Proposed amendments to approved drawings 23/00189/LBC are shown in red.

LITTLE JERICHO BLACKMORE

PROPOSED BLOCK ROOF PLAN

242.15C

Roof Plan 1:100

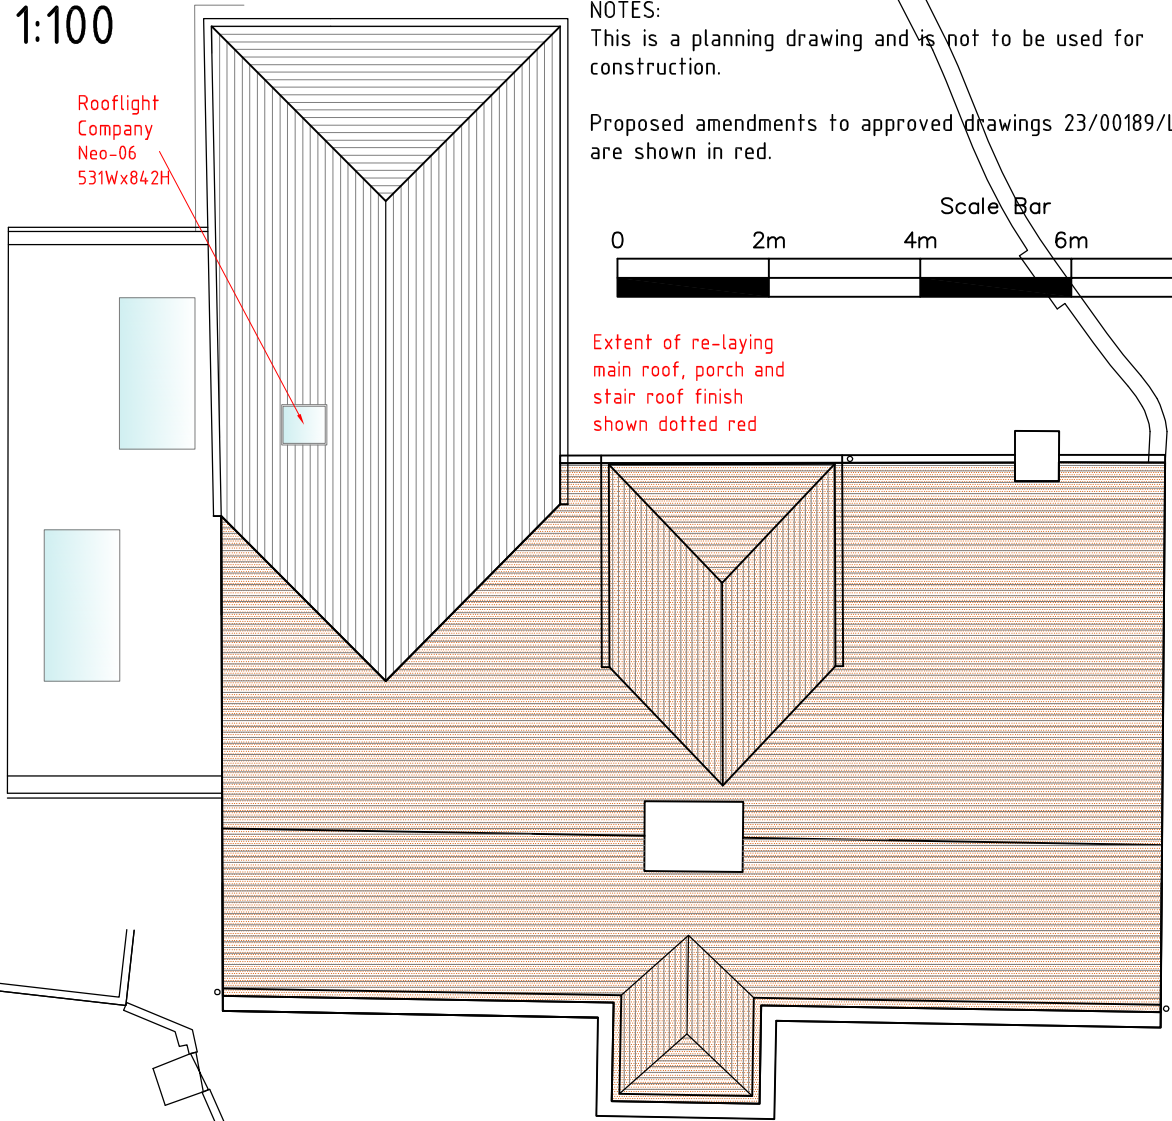
Extent of re-laying main roof, porch and stair roof finish shown dotted red

Allow to re-tile roof using sound existing tiles and making good with matching new clay tiles subject to agreement of sample.
 Allow to lay tiles on breathable felt membrane with hidden eaves vents.
 Allow to carry out localised like-for-like timber carpentry / brick / lead roof repairs if condition unsound (see typical photos).
 Allow to re-lead Code 4 chimney flashing and Code 5 lead valleys and perimeter lead gutter on classic bond fleeceback with Code 5 welted lead capping to match.

Rev B 02.03.2024 Roof repair area hatched. Bath rooflight added.
